UNITED STATES PATENT AND TRADEMARK OFFICE

APPLICATION NO.	FILING DATE	FIRST NAMED INVENTOR	ATTORNEY DOCKET NO.	CONFIRMATION NO.
09/823,600	03/30/2001	David Chong Sook Lim	17732-3856000	6055

Office Action Summary

DETAILED ACTION

Attachment to Paper No. 18

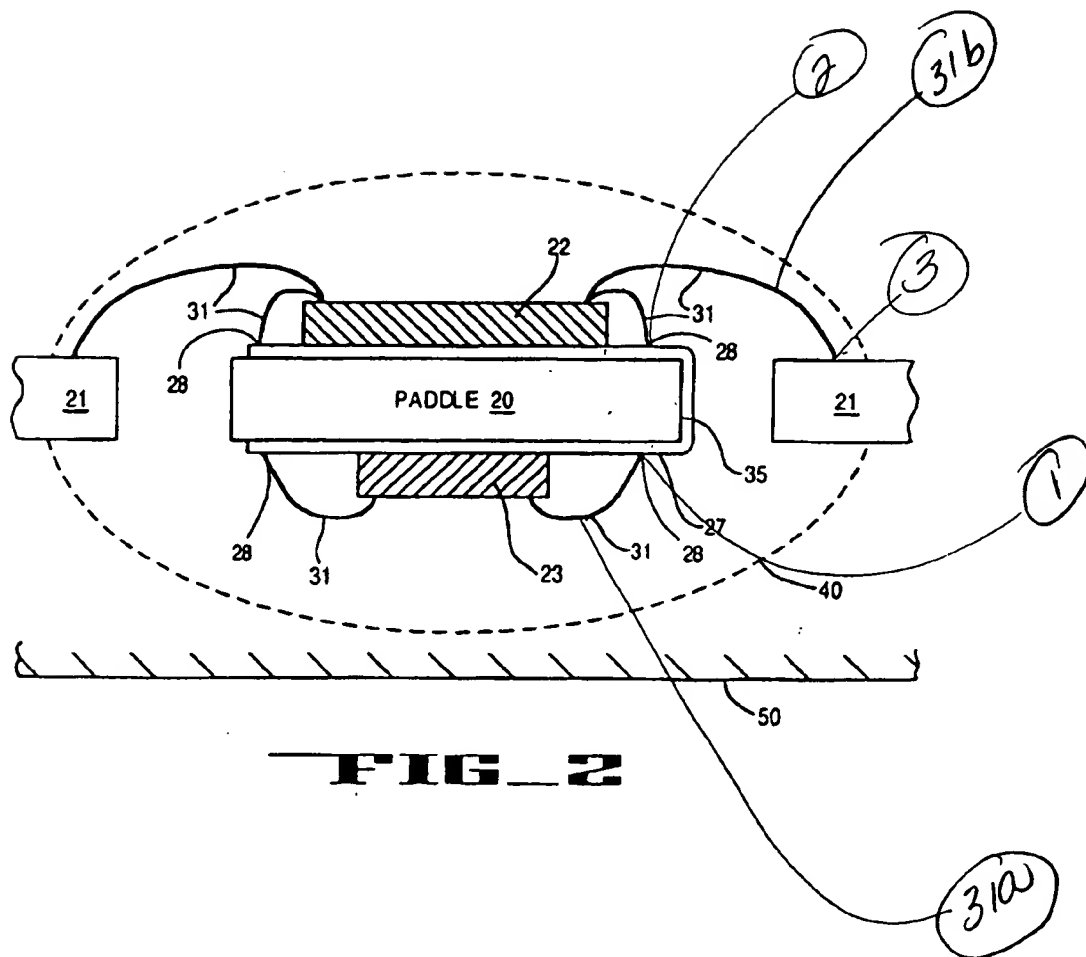
6. Regarding claim 18, Kuhn (see attached figure 2) shows a package having a substrate 20 for receiving a die down die 23 and/or a die up orientation 22. The die down die defines electrical contacts 1. The substrate comprises: a plurality of leads conductive traces (the wiring of the circuit 27) defining first contacts 1 which are arranged to accept connector wires making electrical connections from the electrical contacts of a die down die 23. Also, Kuhn shows second contacts 2 which are arranged to correspond to a die up die 22. The substrate can be placed into a package designed to accept a die up die (i.e. printed circuit board). The electrical connection may be made to the substrate second contacts as if it were a die up die (col. 1/lis. 14-27).

7. Regarding claim 19, Kuhn shows a die down 23 mounted to the substrate having wires 31a joining the electrical contacts of the die down die to the first contacts of the conductive traces. Also, Kuhn shows electrically conductive wires 31 joining the second contacts on the conductive traces to contacts 3 on a lead frame.

10. Regarding claim 45 Kuhn (see attached figure 2) shows a package having a substrate 20 and a lead 21 with contacts 3. Kuhn shows connectors wires 31b joining

the second contacts on the trace to the lead frame contacts. Also, the lead frame provides means to make electrical connection to a printed circuit board (col. 1/lls. 14-27).

18. Applicant argues that Kuhn does not describe the chips with respect to pad orientation, nor does consider pad orientation anywhere in this patent. This argument is not persuasive since Kuhn's figure 2 clearly shows a substrate that is capable to accept a die down die 23 as well as die up 22. Although the applicant uses terms different to those of Kuhn to label the claimed invention, this does not result in any structural difference between the claimed invention and the prior art. The use different terminology to describe the plurality of elements that constitute an integrated circuit, as this is just a writing style and the way in which a structural limitation is expressed does not affect the configuration of the described elements.

19. Applicant argues that Kuhn does not make connections from his contact 21 to chip 23. Nonetheless, Kuhn's figure 2 clearly shows that the chip 23 is electrically connected to the contacts via the traces 27 and the chip 22. Kuhn discloses that the lead frame 21 is used to externally connect the chips (i.e. 22, 23, col. 1/lis. 14-27). Moreover, this limitation is not recited in the rejected claim(s). Although the claims are

20. Applicant argues that Kuhn does not suggest a package designated to accept a specific die orientation where a die with different orientation can be mounted. Nevertheless, Kuhn discloses a substrate that is capable to receive a die up orientation or a die down orientation as evidenced by figure 2.
